CONSTRUCTION PLANS FOR CREEKSIDE AT LORSON RANCH FILING NO. 1 STREET AND STORM SEWER CONSTRUCTION PLANS

Engineering Review

PUDSP-18-005
SF-19-00X

**CREEKSIDE AT LORSON RANCH FIL NO. 1
STREET / STORM SEWER
CONSTRUCTION PLANS**

STREET/STORM CASTOR DRIVE STA 7+50 TO 15+00

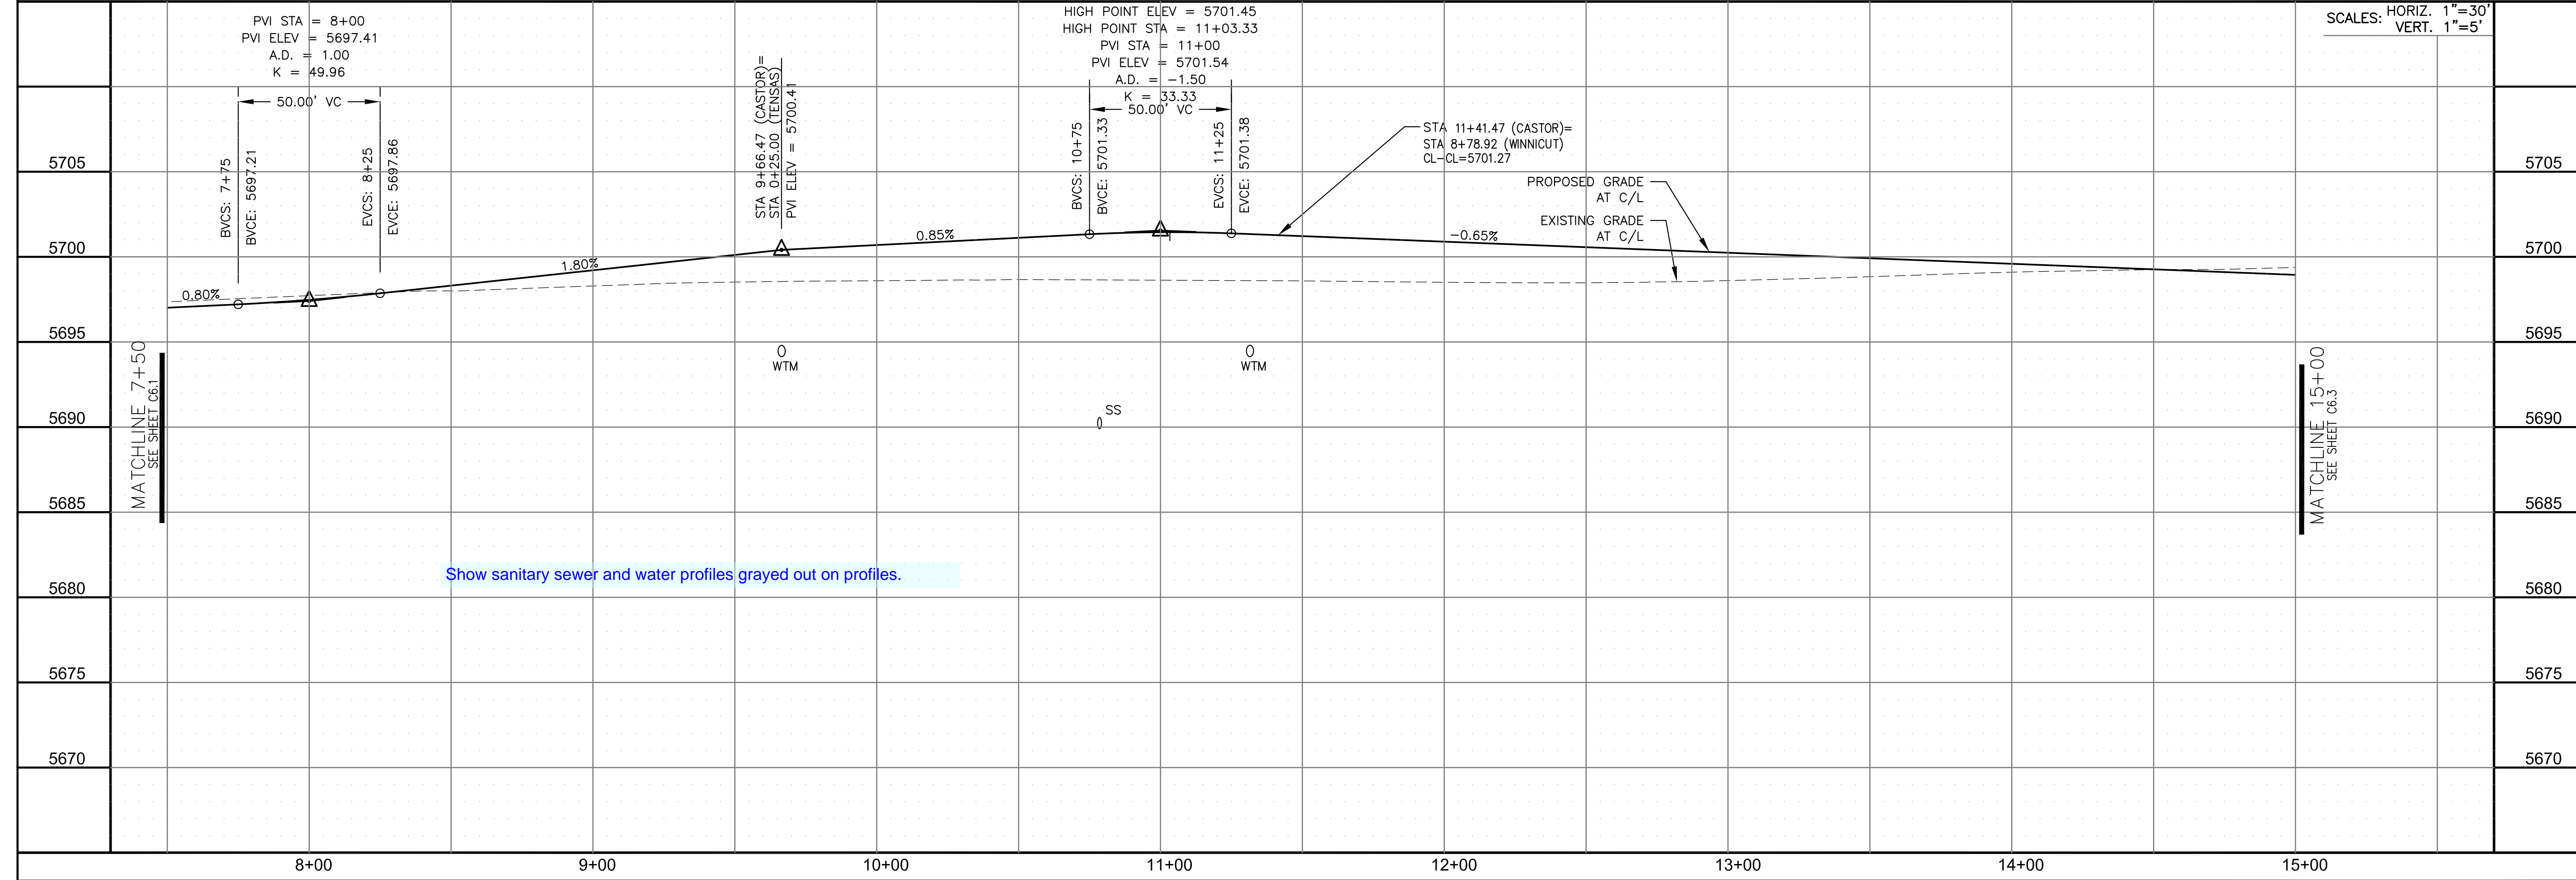
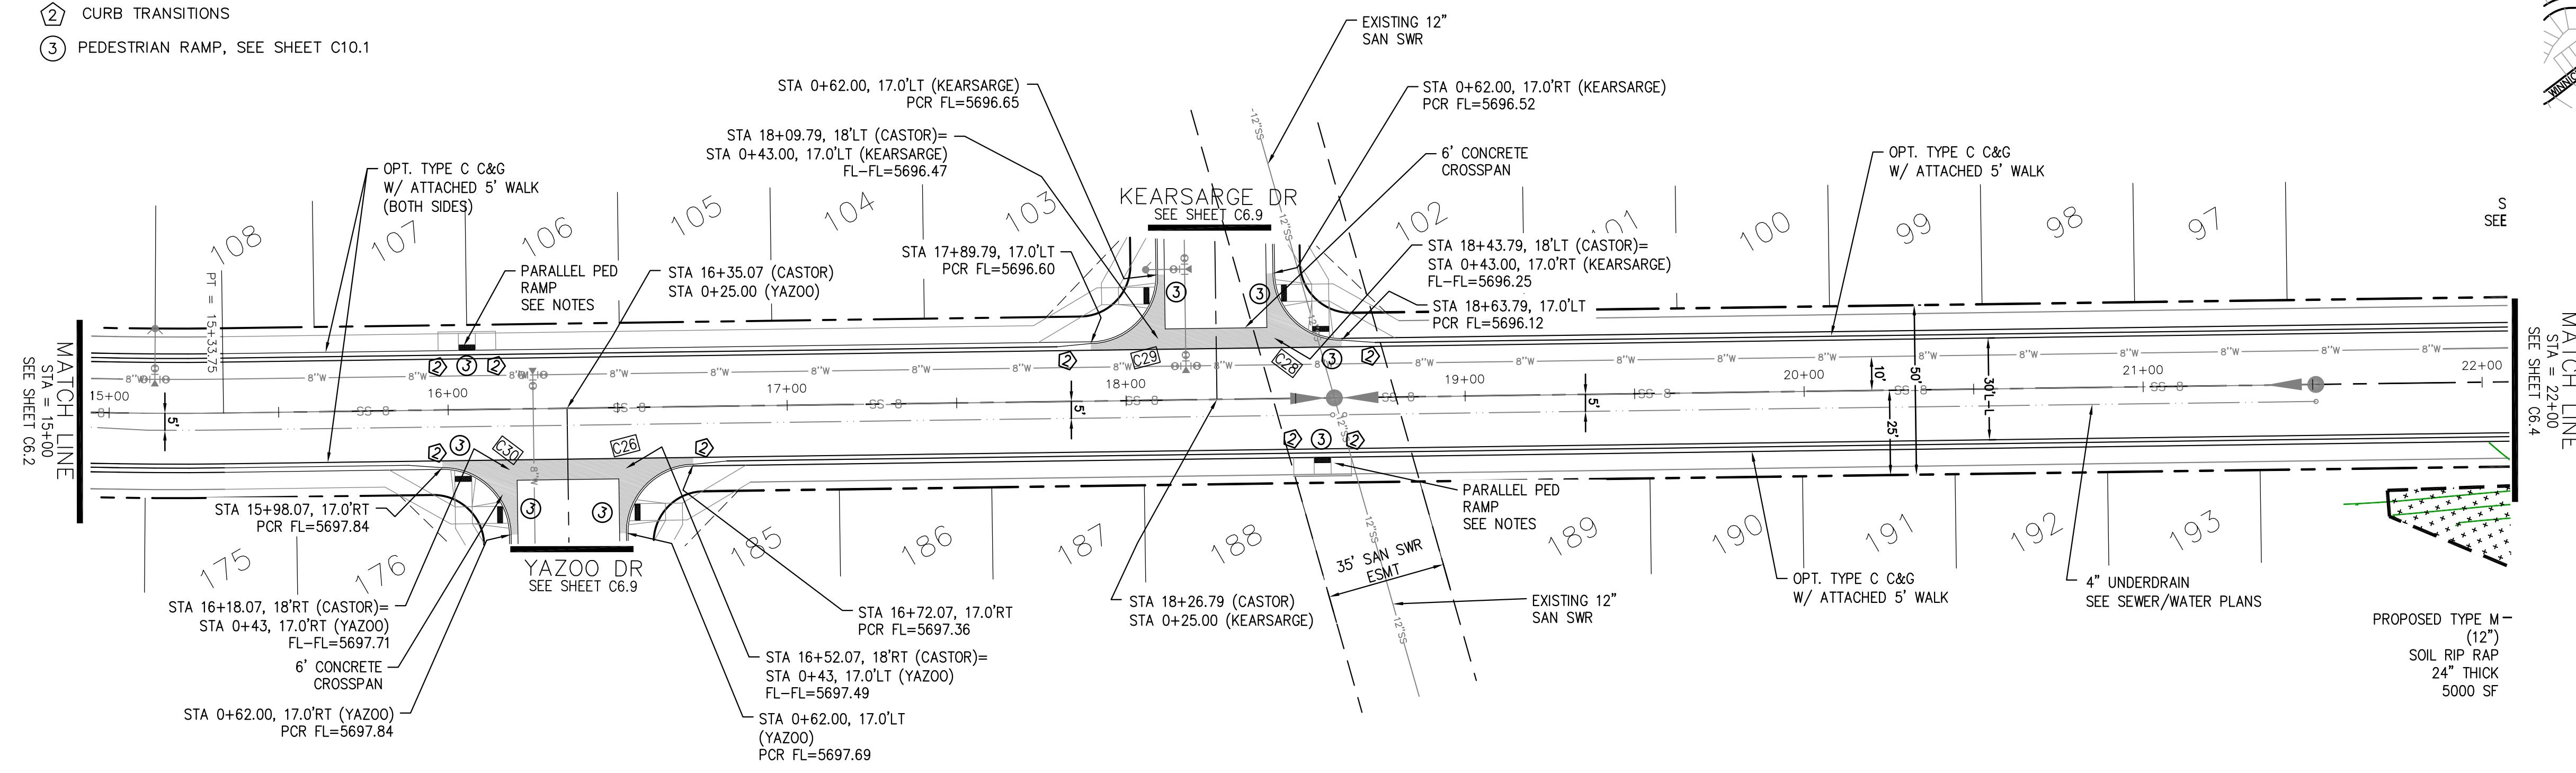
Show sanitary sewer and water profiles grayed out on profiles.

**STREET/STORM
 STORM LATERAL 'B'**

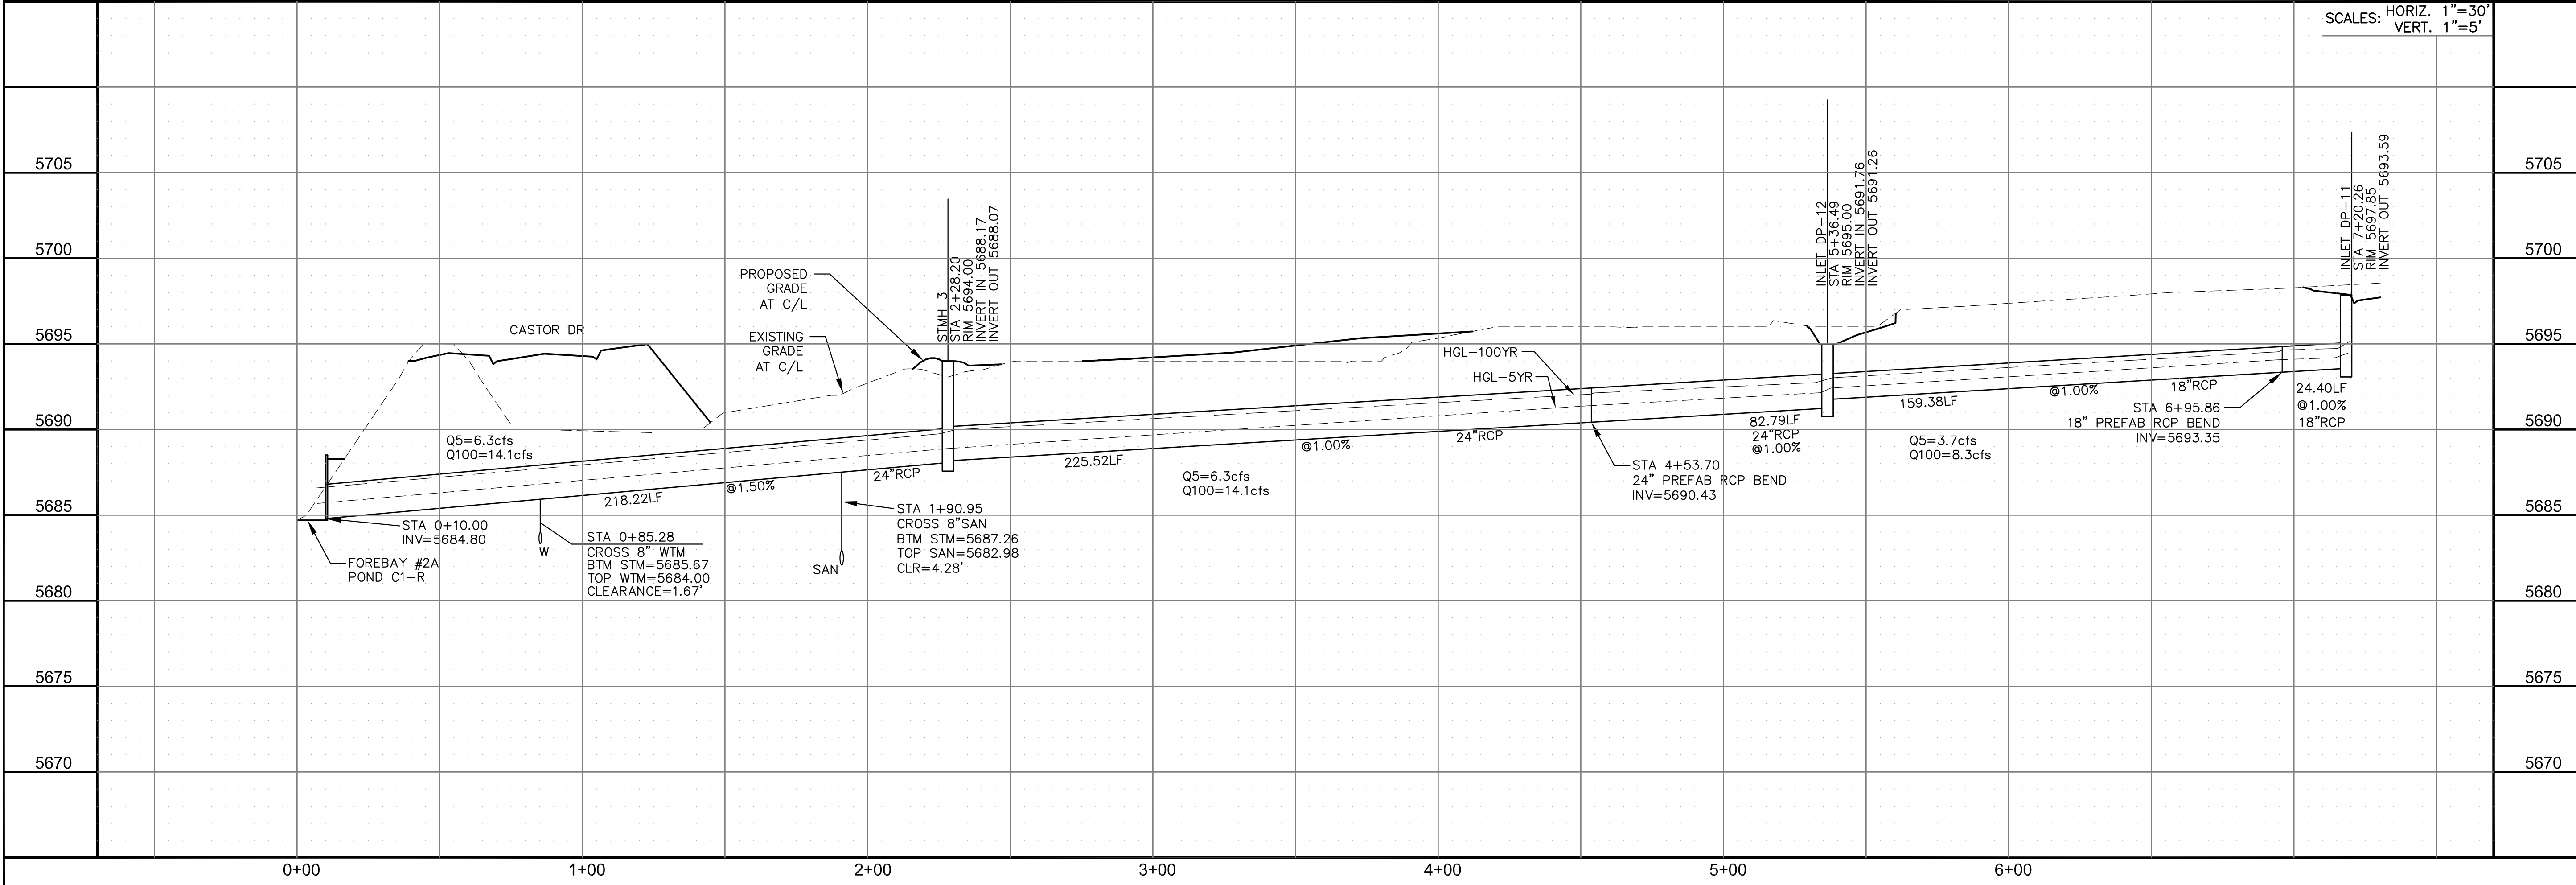
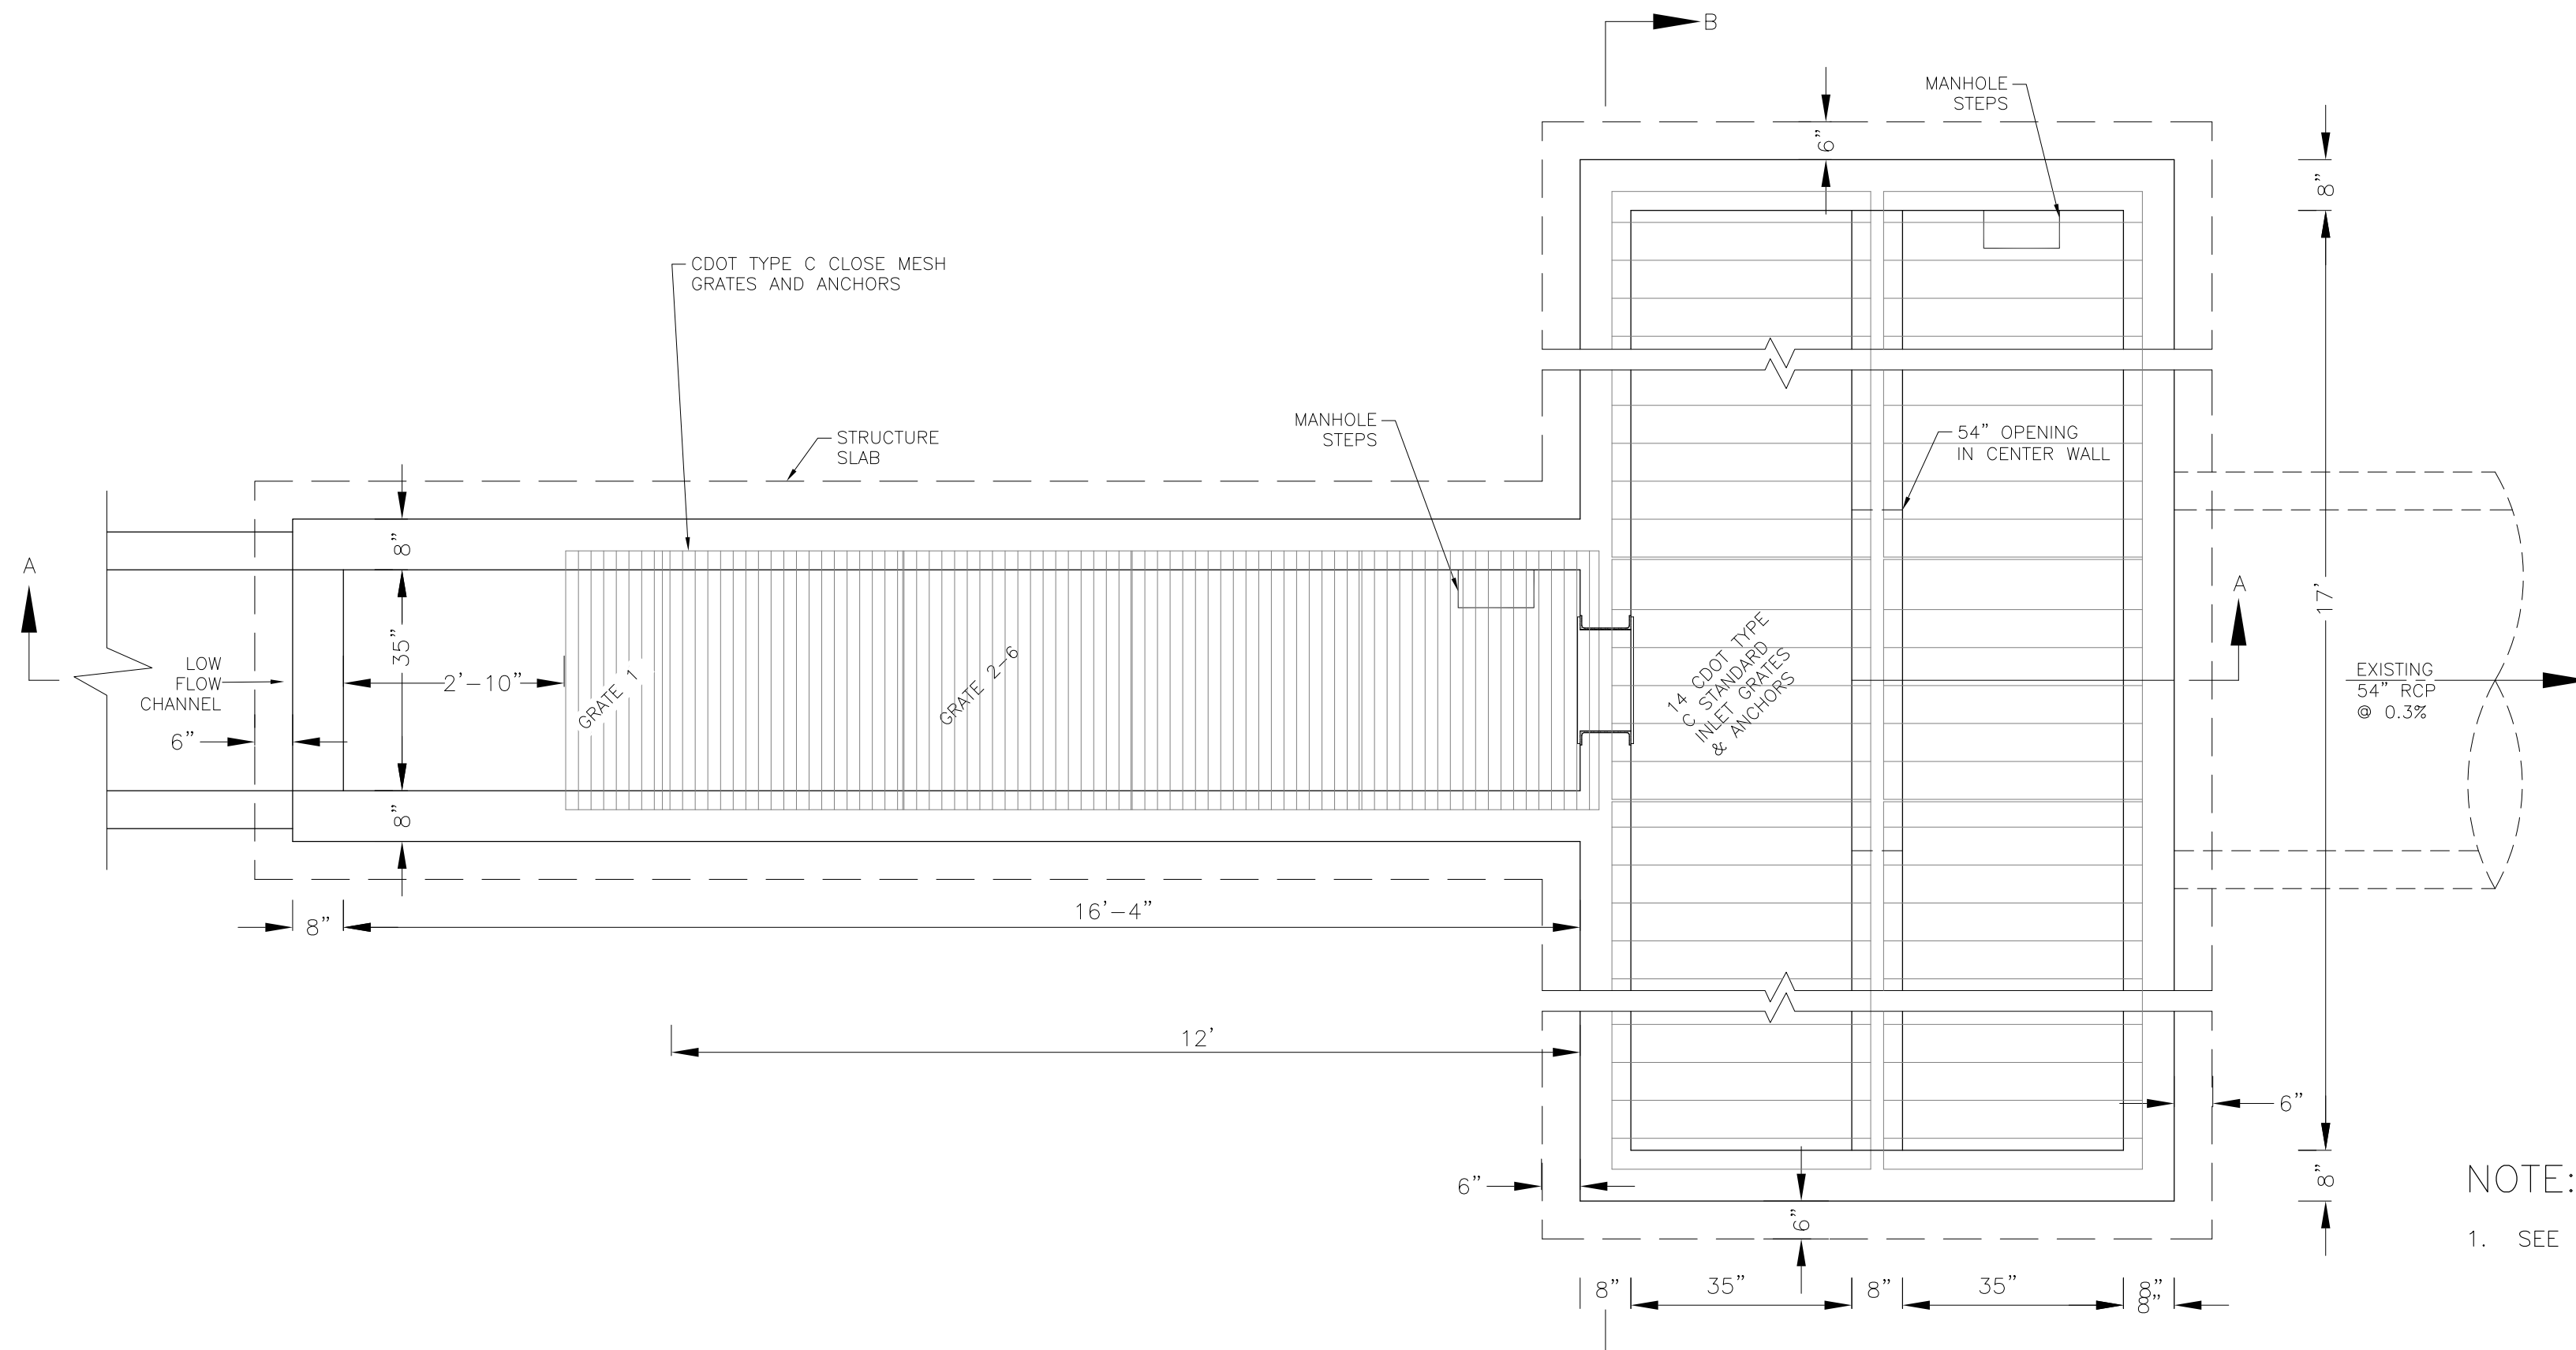
Label all storm plans as "public" or "private" or "metro district"

recommend curvilinear pipe or manhole
Show easements or label tracts.
